**TRANSMISSION—4R70W—NEW SERVICE PART—  
NUMBER 5 NEEDLE BEARING AND RACE KIT—  
SERVICE TIP**

**Article No.  
03-26-1**

Figure 1 - Article 03-26-1

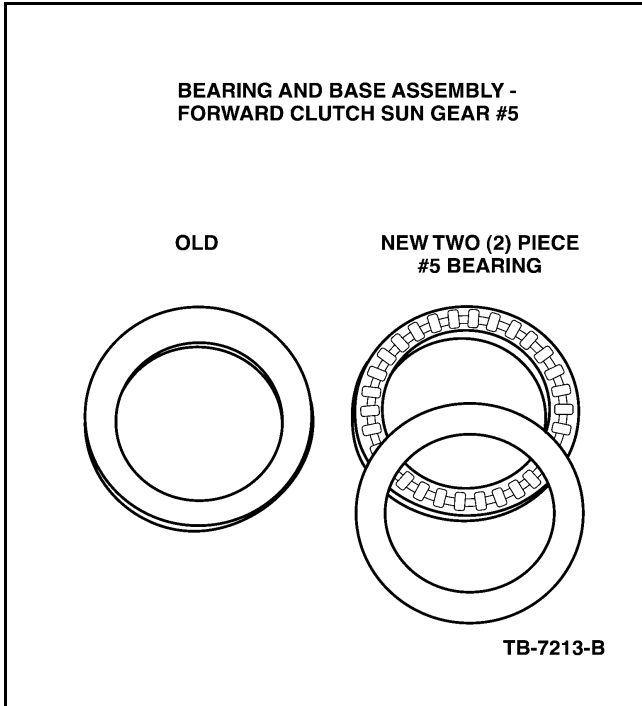
A new Service Kit 4L3Z-7D234-AA has been produced to eliminate the mismatch of service parts. The kit contains the following:

- A new two (2) piece number five (#5) thrust bearing assembly (7D234 bearing and 7D235 race) (Figure 1)
- A forward clutch sun gear (7A399) (Figure 2)
- A reverse sun gear (7A019) (Figure 3)
